UNITED STATES  
DEPARTMENT OF THE INTERIOR  
BUREAU OF LAND MANAGEMENTNM OIL CONSERVATION  
OCDEP DISTRICTFORM APPROVED  
OMB NO. 1004-0135  
Expires: July 31, 2010**SUNDRY NOTICES AND REPORTS ON WELLS**  
*Do not use this form for proposals to drill or to re-enter an abandoned well. Use form 3160-3 (APD) for such proposals.*

5. Lease Serial No.  
NMNM67980
6. If Indian, Allottee or Tribe Name
7. If Unit or CA/Agreement, Name and/or No.
8. Well Name and No.  
SANTA FE FEDERAL 3
9. API Well No.  
30-015-27026
10. Field and Pool, or Exploratory  
DELAWARE
11. County or Parish, and State  
EDDY COUNTY COUNTY, NM

## Santa Fe Fed #3 Plug and Abandon Procedure

### Santa Fe Federal 3 Proposed WBD

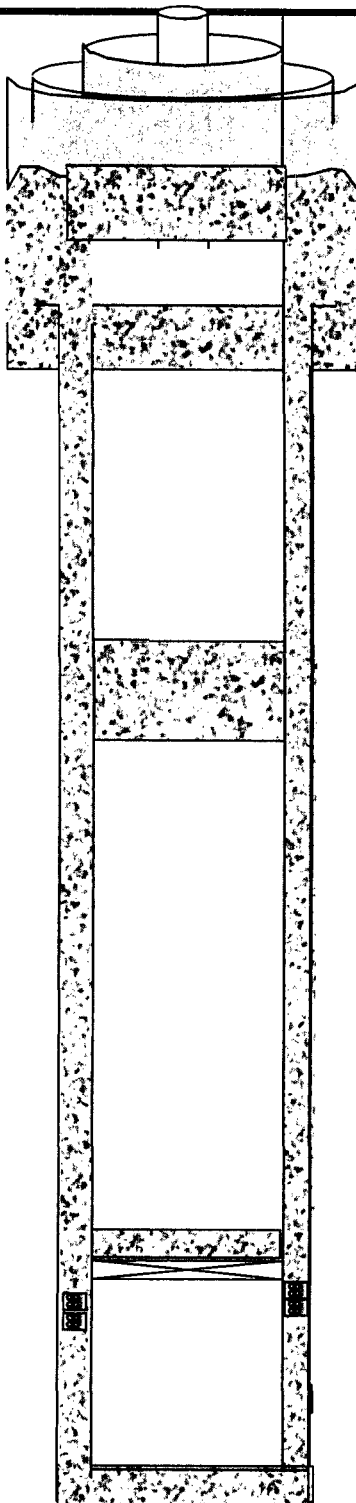
- 7) WOC & Tag *Add Plug (DVT) From 5075 - 4925. WOC Tag*
- 8) PU & LD tbg. to 2850' - Spot ~~45~~ <sup>*Adequat*</sup> sxs from 2850' - 2450'. *2310*
- 9) PU & WOC - Tag cmt. - Max tag ~~2450~~ <sup>*2310*</sup>. *550*

- 10) RU WL & Perforate 4 holes @ ~~500~~ <sup>*550*</sup>'. RD MO wireline.
- 11) RIH w- Pkr & tbg. - set Pkr @ 240' - Attempt to establish pump rate. Squeeze 40 sx Class C Cement (14.8 ppg, 6.3 gps, 1.32 cfs yield).

- 12) WOC & Tag @ ~~432~~ <sup>*400*</sup>'
- 13) If good cement bond and unable to squeeze - Spot 60 sxs from ~~500~~ <sup>*600*</sup>' to surface. If tagged cmt. @ ~~450~~ <sup>*400*</sup>' - spot 25 sxs cmt. from 150' to surface.
